FCA/ Flood Management Plan

**Salem Chapel Brynawel Crynant Neath Port Talbot
SA10 8SR**

Change of use to residential care home (Class C2)

- 1.1 This document has been prepared in support of a planning application for the change of use of a church (Class D1) to residential care home (Class C2) and to address the comments of the LLFA on the 10th August 2026

Figure 4

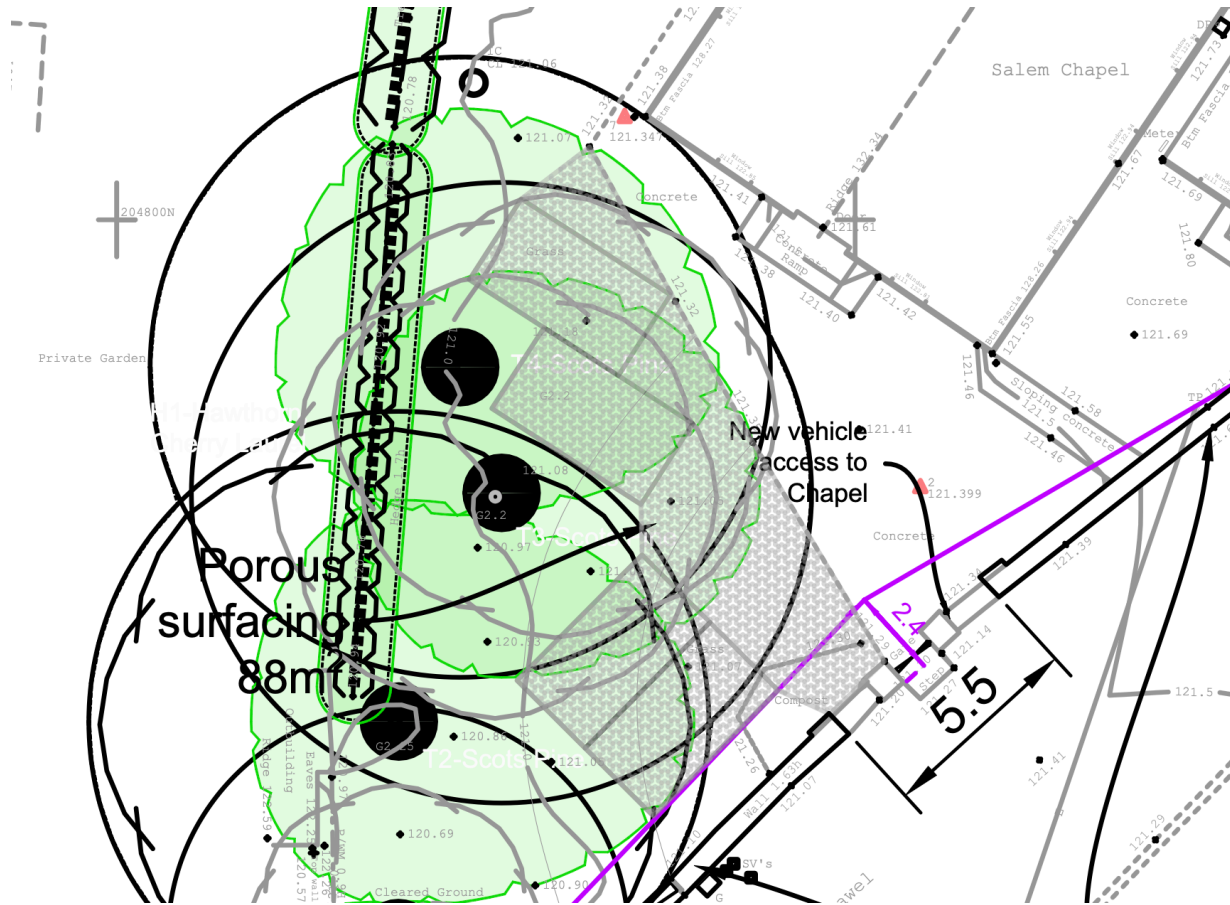
<i>LLFA Comments</i>	<i>Reply</i>
The exceedance flow arrows shown on the proposed site layout do not appear to correspond with the surveyed site levels. The indicated flow path appears to direct runoff towards areas of higher ground in places. Could they please review and amend accordingly.	Revised details and plan provided. <i>Paragraph 2.5 & Exceedance routes Rev A</i>
In relation to the proposed permeable paving, the response explains the reason for selecting the surface but does not demonstrate its suitability. Further information is required regarding how surface water run-off from the proposed parking area will be managed and to justify the proposed drainage approach.	Matters in relation to infiltration and detailed design can be dealt with by a suitably worded condition attached to the planning permission.
Maintenance arrangements for the proposed permeable paving should be confirmed.	These matters can be dealt with by a suitably worded condition attached to the planning permission.
